UNITED STATES PATENT AND TRADEMARK OFFICE

| APPLICATION NO. | FILING DATE | FIRST NAMED INVENTOR | ATTORNEY DOCKET NO. | CONFIRMATION NO. |
|-----------------|-------------|----------------------|---------------------|------------------|
| 10/686,857 | 10/16/2003 | Andrew M. Hiles | HAM-100-A | 1733 |

Office Action Summary

DETAILED ACTION

Exhibit A

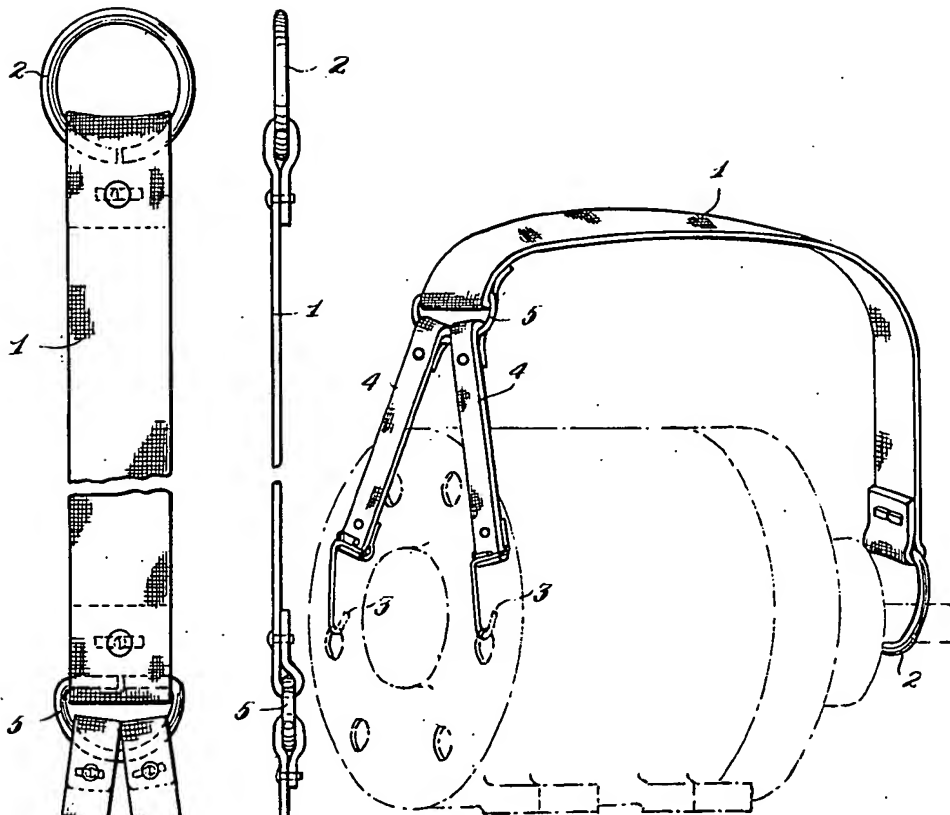
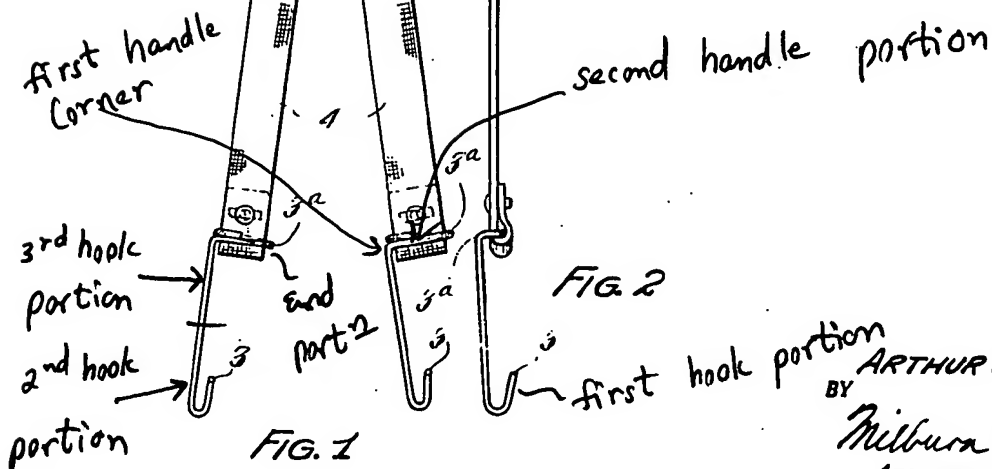
Vickers (2,541,449) discloses a lifting device comprising: a hook member (Figs. 1 and 2) configured in a predetermined shape having a substantially tapered end portion (see Fig. 2) and a second end portion; said hook member is provided with a predetermined opening between said tapered end portion and said second end portion; a fabric strap member (4) operably connectable to said hook member so that said strap member serves as a handle and an attachment to connect said hook member to an external pulling mechanism (2). It is pointed out that the prior art discloses all the structural limitations while the intended use (i.e. *for dragging a game animal and for gaffing a fish or marine animal*) is not patentably significant.

Re claims 3 and 4, Vickers (2,541,449) meets the limitations as broadly as recited in the claims (**see Exhibit A**).

Exhibit B

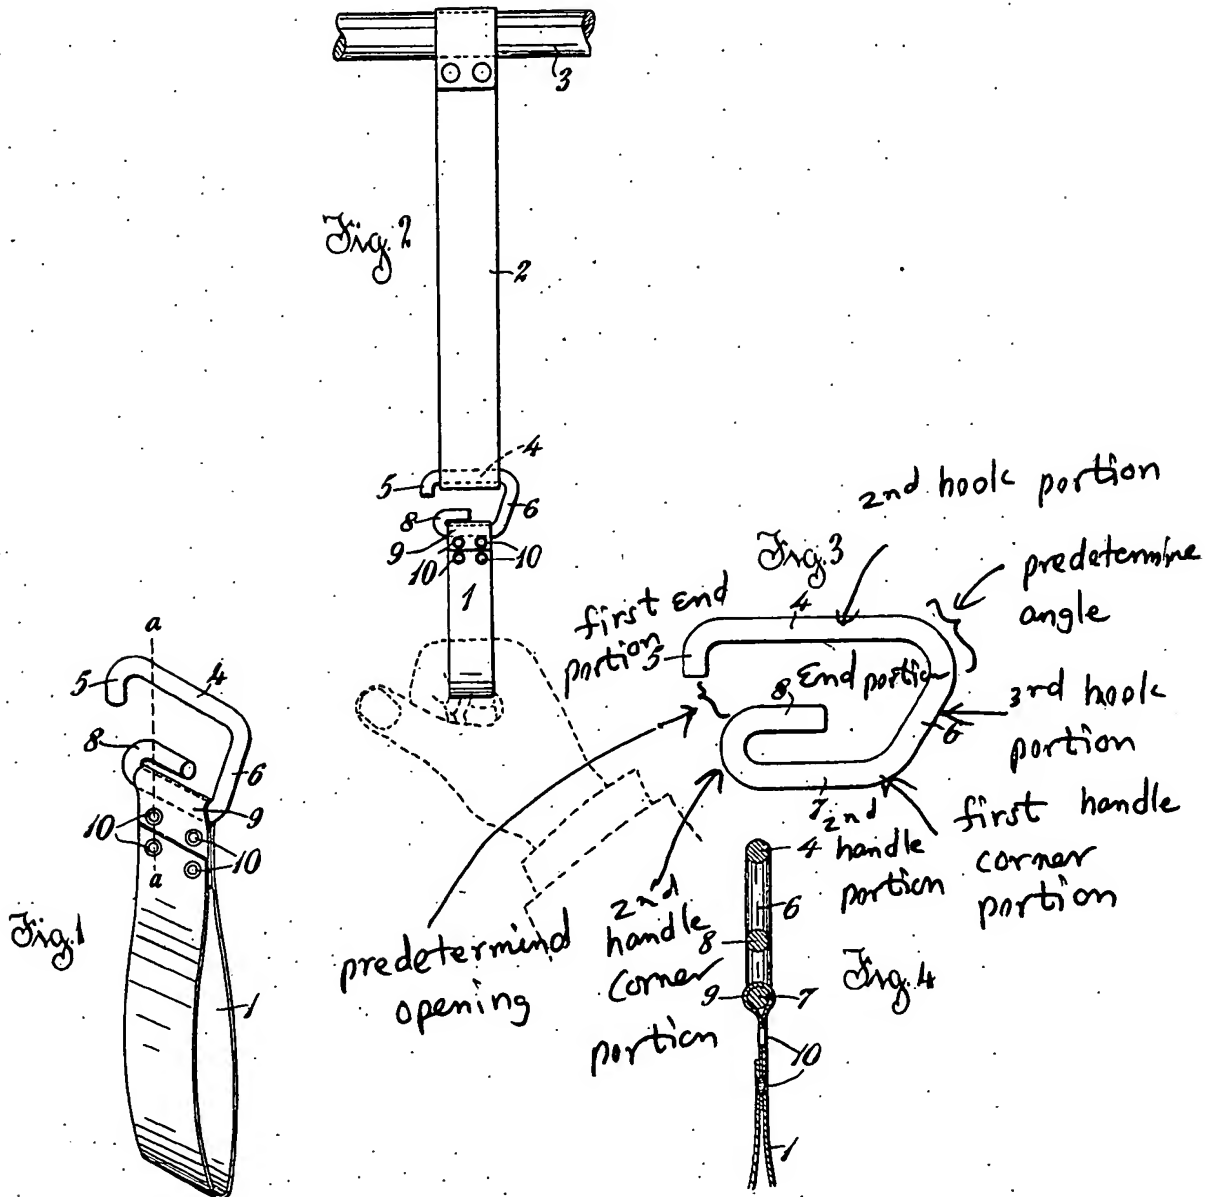
Autenrieth (937,564) discloses a lifting device comprising: a hook member (Figs. 1-3) configured in a predetermined shape having a first end portion (5) and a second end portion (8); said hook member is provided with a predetermined opening between said first end portion (5) and said second end portion (8); a strap webbing member (1,2) operably connectable to said hook member so that said strap member serves as a handle and an attachment to connect said hook member to an external pulling mechanism. Autenrieth (937,564) does not show a first end portion having a tapered end portion. However, Lutz (2,307,327) discloses a pointed member (12) having a tapered end portion (16) which has a tapered angle between 30 to 45 degree. Accordingly, it would have been obvious design choice to those skilled in the art to provide a tapered angle between 30 to 45 degree on the first end portion (5) of Autenrieth (937,564) as taught by Lutz (2,307,327) so that the end portion would be easily attached to the strap member (2). It is pointed out that the modified Autenrieth (937,564) discloses all the structural limitations while the intended use (*i.e. for dragging a game animal and for gaffing a fish or marine animal*) is not patentably significant. Re claims 3 and 4, the modified Autenrieth (937,564) discloses all the structural limitations (**see Exhibit B**). Re claims 13-20, the angle between the second hook portion and the third hook portion is a predetermined (see Exhibit B).
